ADDENDUM NO. 2

23 January 2017

RE: MILLER PARK DISTRICT PHASE 1
Contract no. R-14-011-201

FROM: Spackman Mossop Michaels / Eskew+Dumez+Ripple, Joint Venture
365 Canal Street, Suite 3150
New Orleans, Louisiana 70130
(504) 561-8686

5 DETAIL OF VEHICULAR TO PEDESTRIAN PAVER APPLICATION, TYP
L11.0 1" = 1"

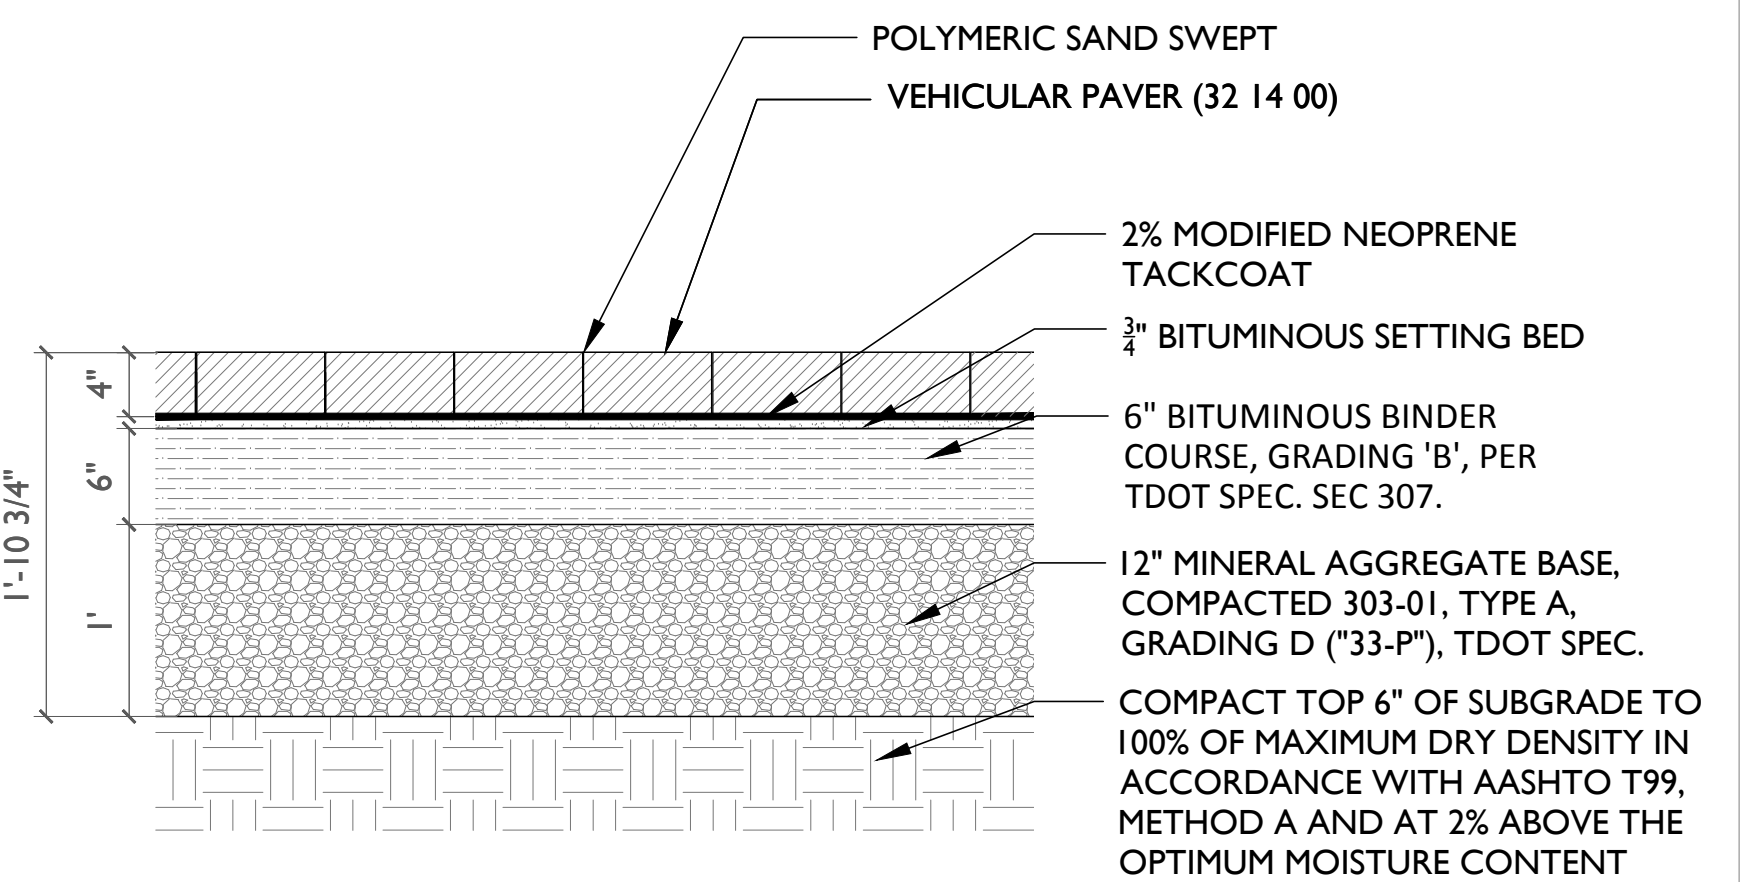
- BB. L7.11- PAVING PATTERN PLAN: Added Match Lines
- CC. L7.12- PAVING PATTERN PLAN: Added Match Lines
- DD. L7.13- PAVING PLAN DETAILS: Adjusted 1/L7.13 and 3/L7.13.
- EE. L11.0- SITE DETAILS: Adjusted 5/L11.0 and 6/L11.0
- FF. L11.1- GARDEN TERRACE DETAILS: Added detail 8/L11.1
- GG. ES1.1 Revised key notes 18 and 20. Revised location for all note 18 food truck electrical services. Adjusted city street lights along 10th street. Added "General City Street Lighting Note". Added two street lighting poles on Market Street near 10th street.
- HH. ES1.2, Revised key note 1. Added "General City Street Lighting Note".
